Your Ref.: A/TM-SKW/125

Our Ref.: P23046

Comments from the Lands Department dated 26.3.2024

Comments from the Drainage Services Department dated 26.3.2024

1:500	Plan showing Site Photographs Taken on 26.3.2024 at 17:00	Goldrich Planners & Surveyors Ltd.
March 2024	Lot 270 (part) in D.D. 385 Tuen Mun, New Territories	Plan 8 (P 23046)

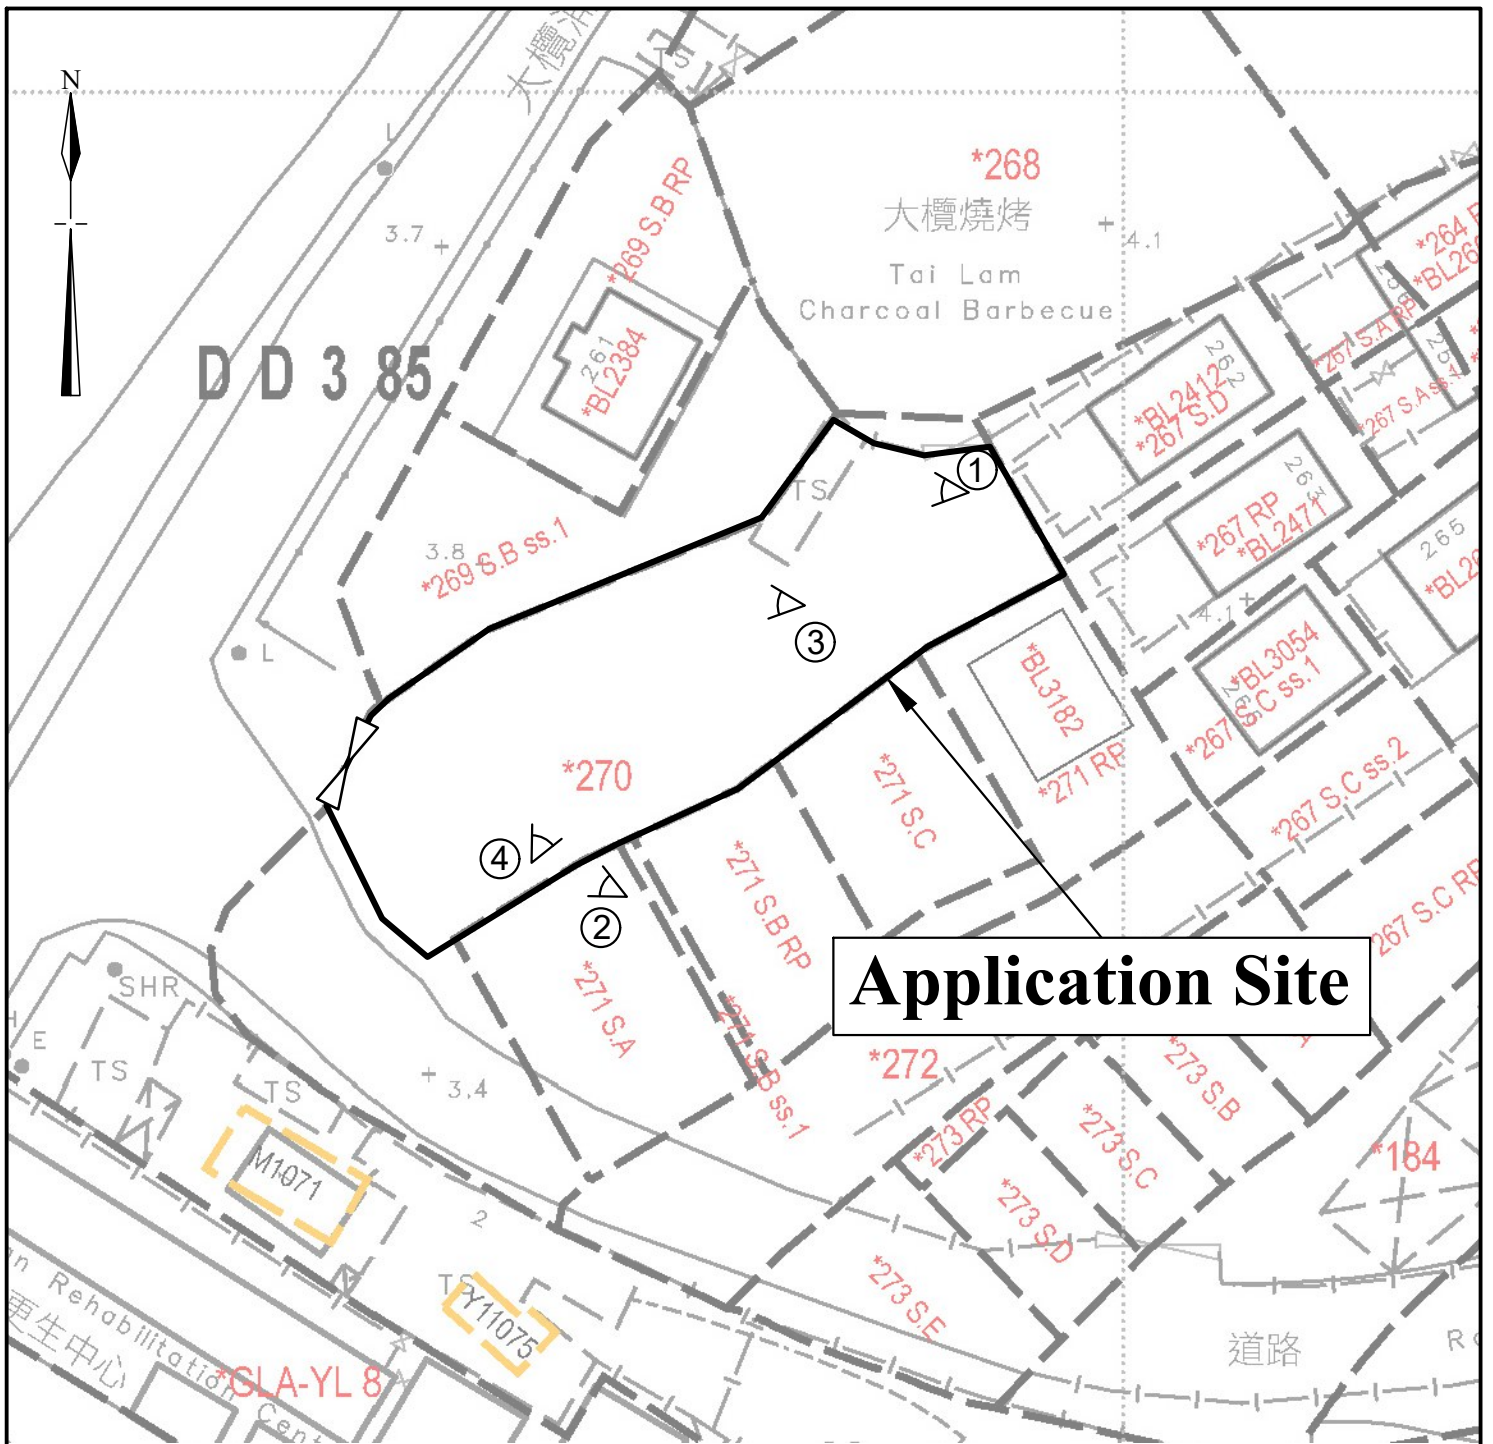
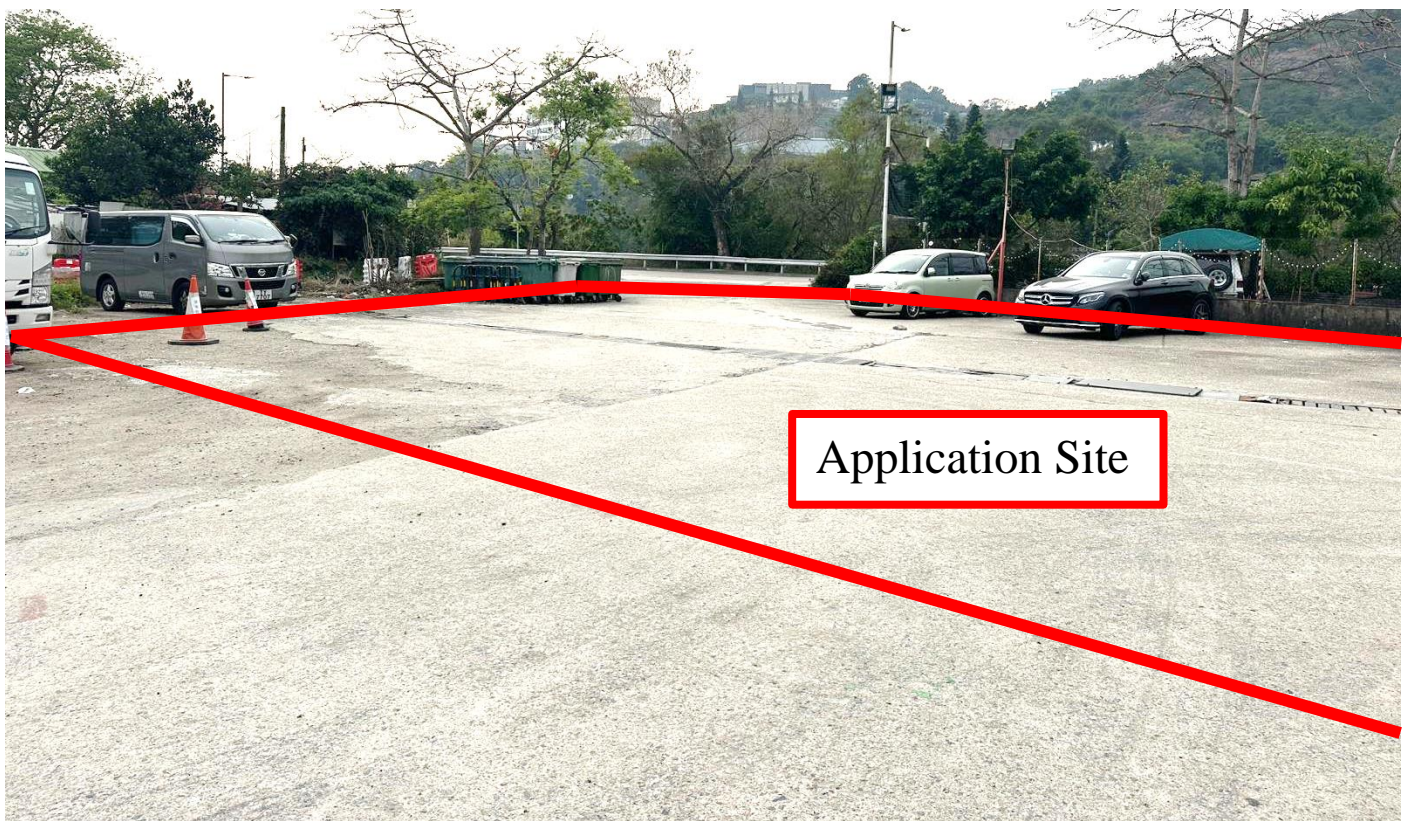
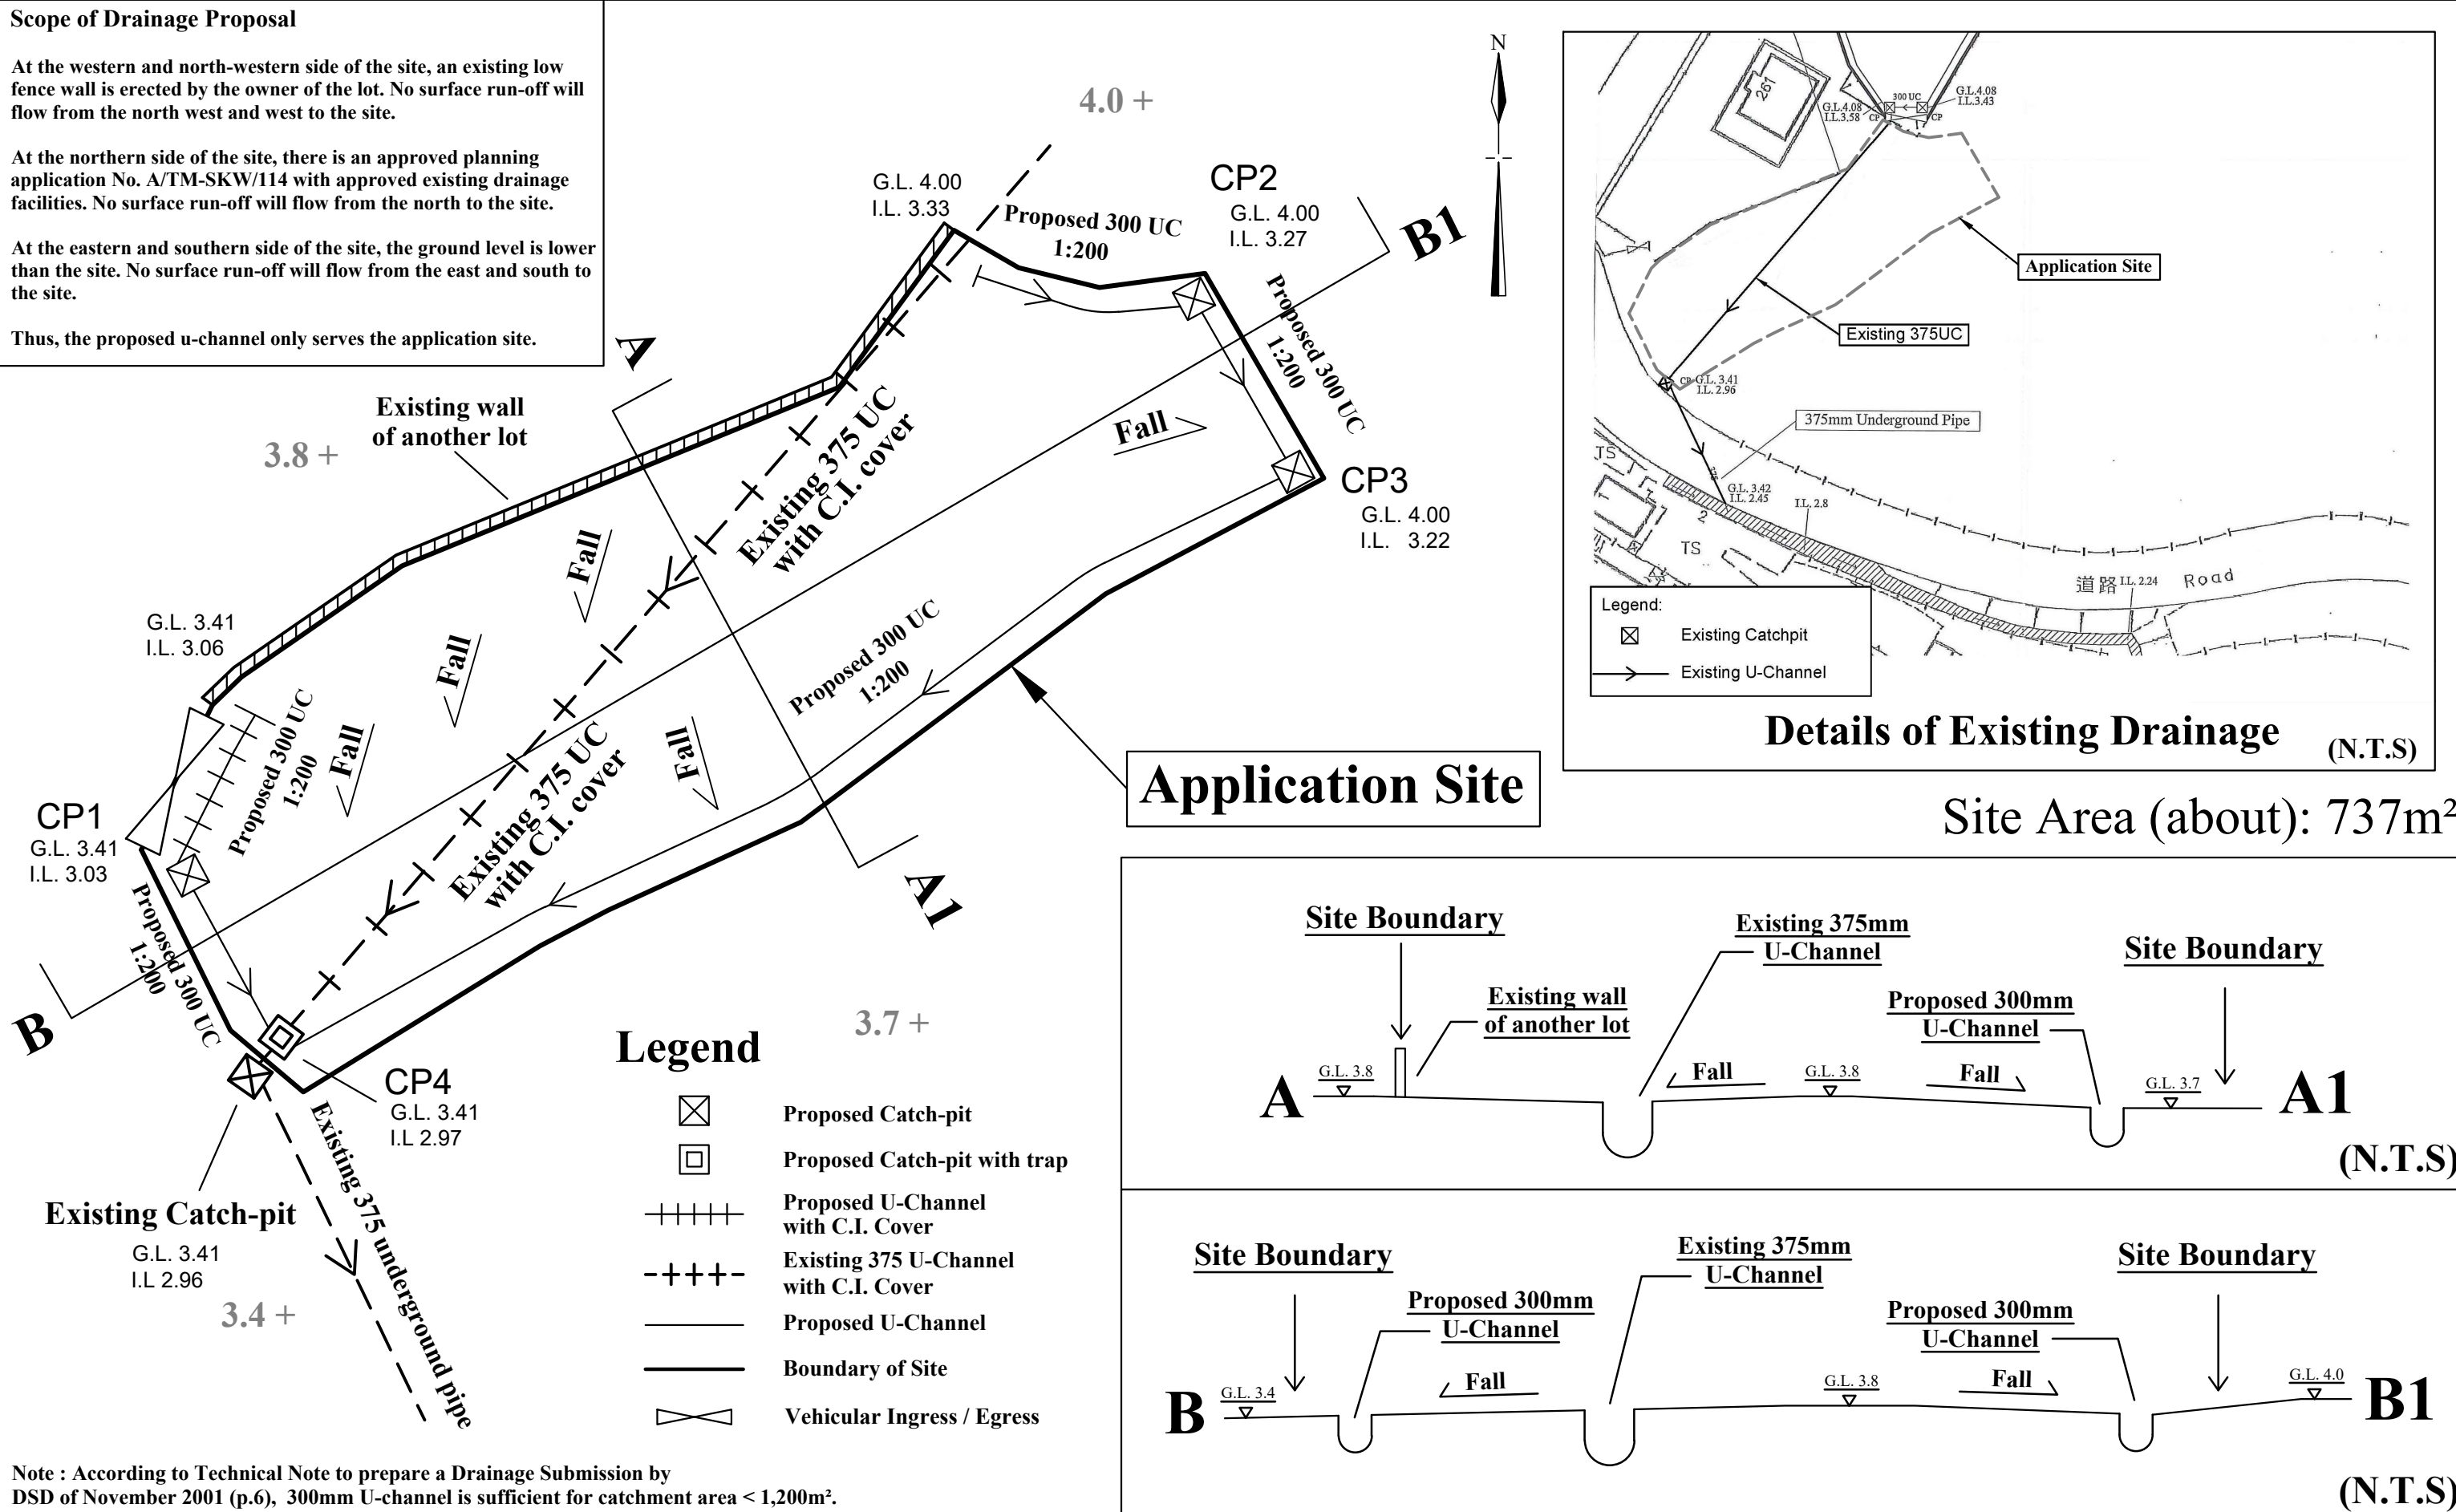
Comments	Responses
1.	The whole application site could not be revealed by the said site photos. The applicant shall provide supplementary site photos imprinted with a date and time showing the whole application site for our consideration.	4 site photographs are attached for consideration.

All site photographs are taken on 26.3.2024 at 17:00
